**Subject** ▶ Change on motor housing, carbon brush and brush holder

**For Models** ▶ HM1500 (Demolition Hammer)

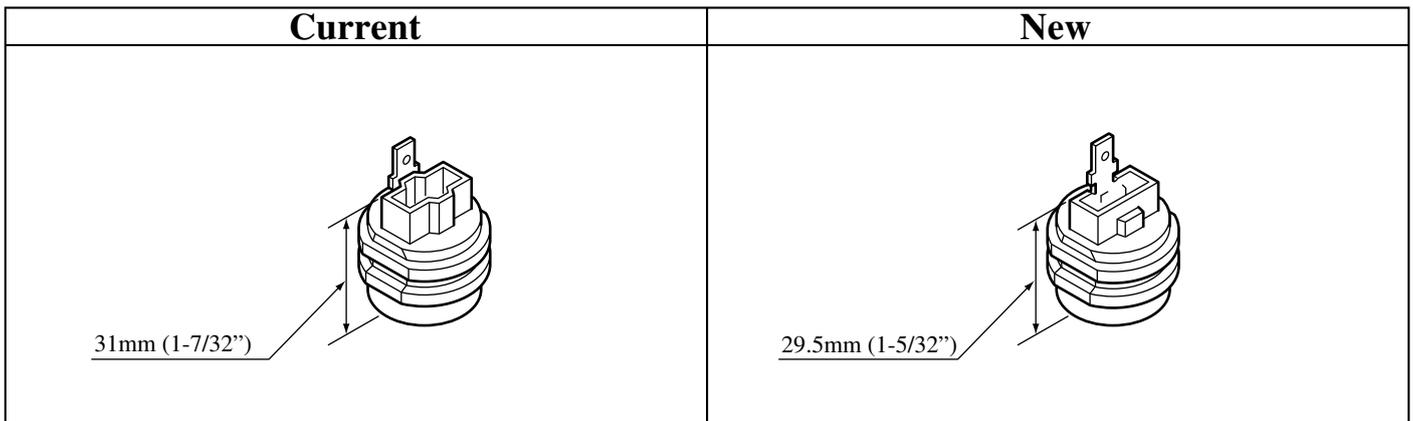
1. The holes for accepting the brush holder in the motor housing will be changed from 18.5mm (23/32") to 20.5mm (13/16") in depth.

2. The brush holders will be changed as shown in the figures below.
